Appendix N – Drawing 2245-12 “Proposed Basement Plan” of the 2023/0285/L consent (annotated) – Nos.18-20.

Appendix M – No.20 rear rooms: Damaged chimney breasts

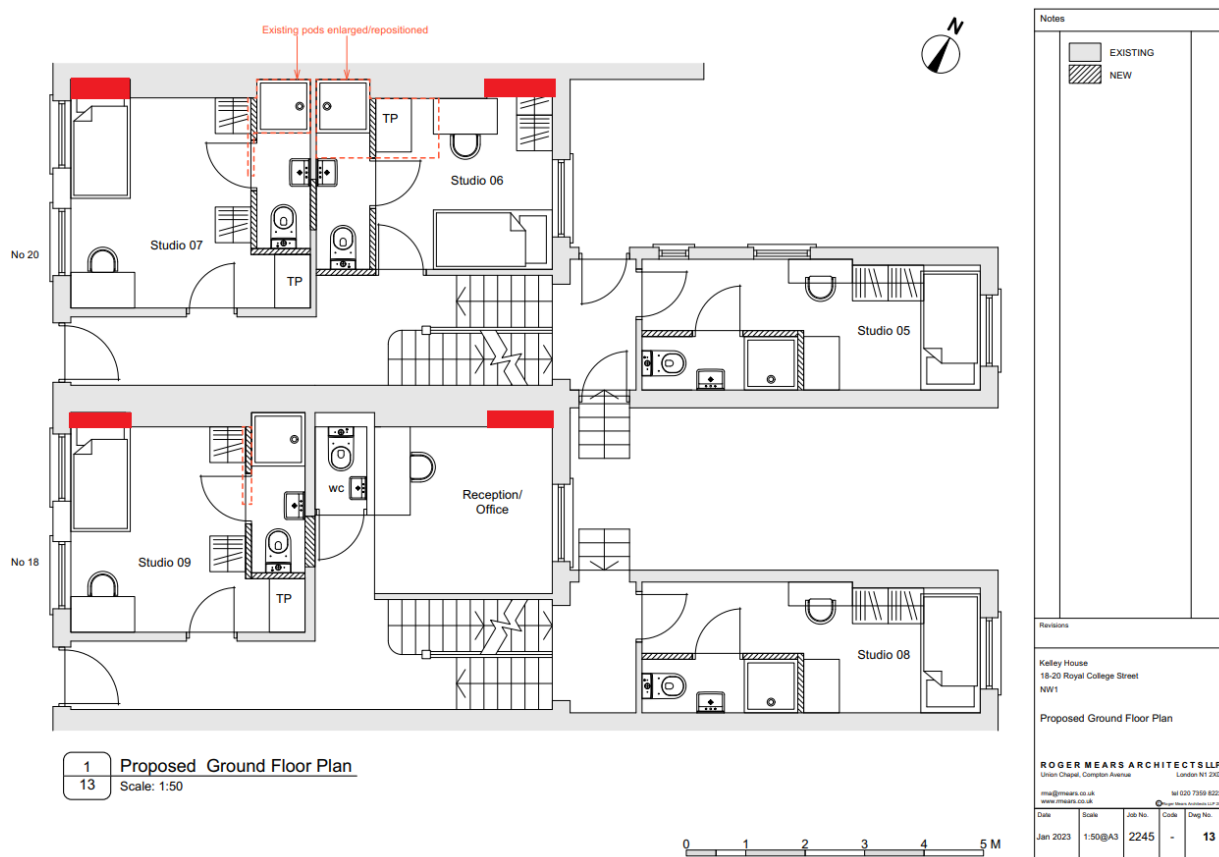
Ground floor [left] & first floor [right]: Damaged chimney breasts (circled in orange).

Appendix P – Drawing 2245-14 “Proposed First Floor Plan” of the 2023/0285/L consent (annotated) – Nos.18-20.

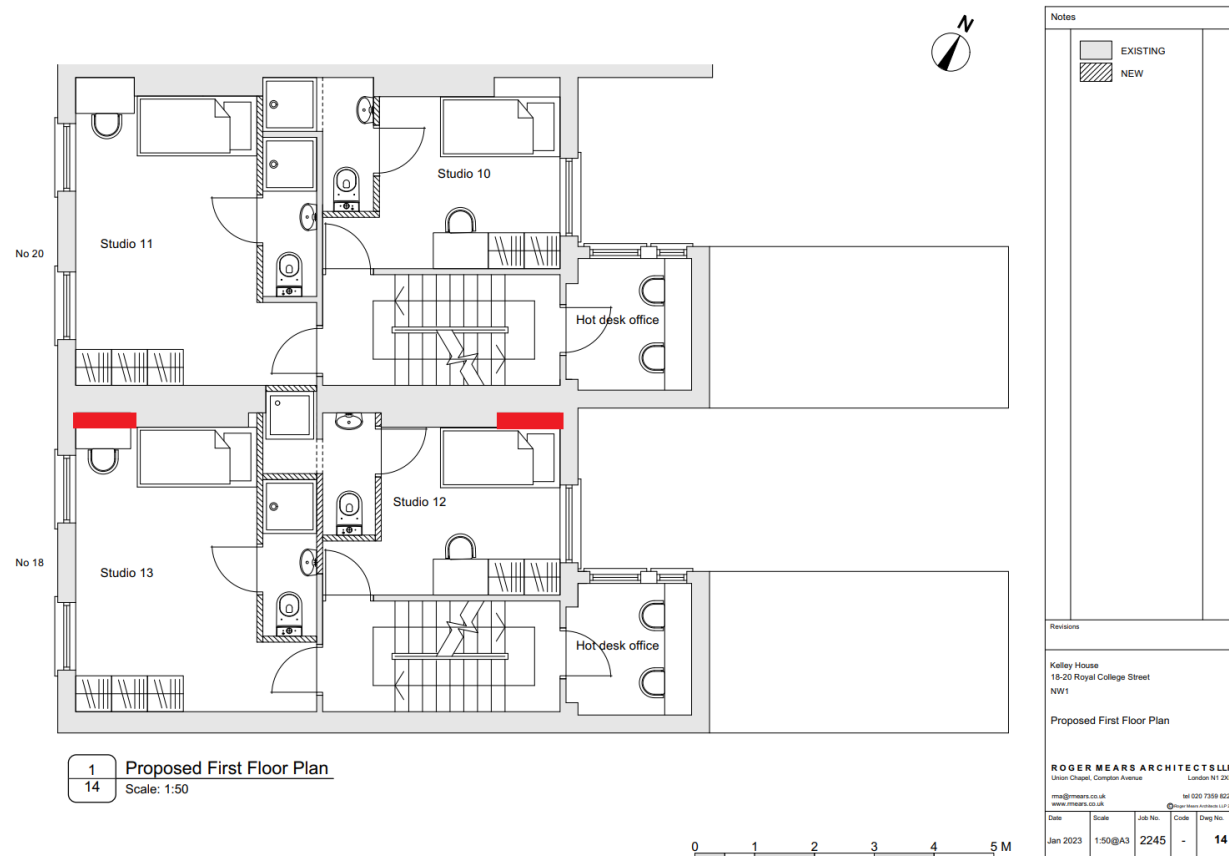
Red box annotations showing the positions of the alcoves which have been infilled at first floor level.

Appendix Q – Drawing 2245-15 “Proposed Second Floor Plan” of the 2023/0285/L consent (annotated) – Nos.18-20.

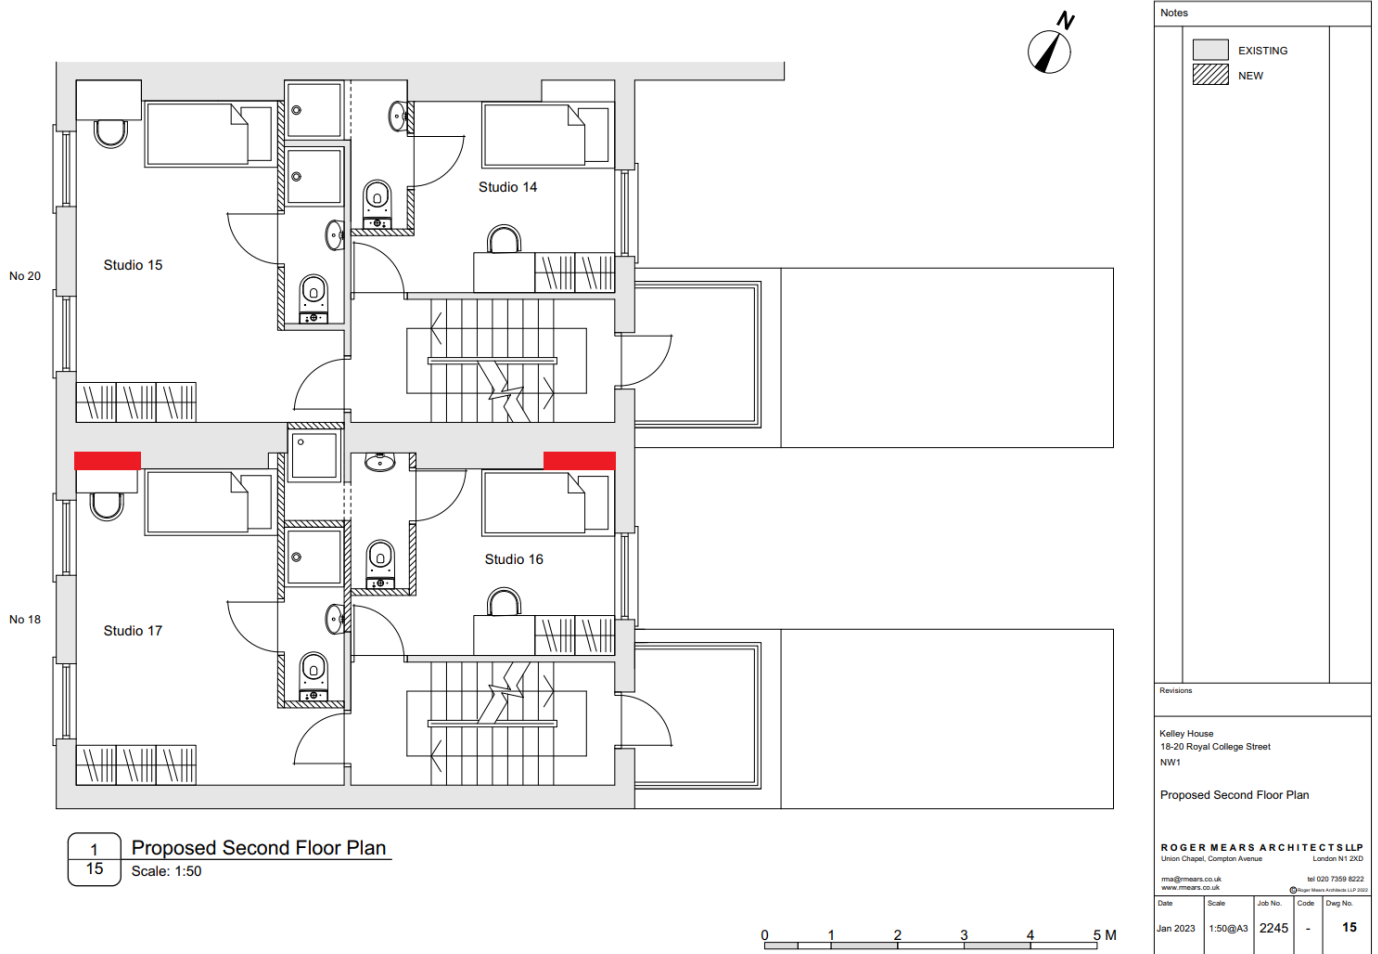
Red box annotations showing the positions of the alcoves which have been infilled at second floor level.
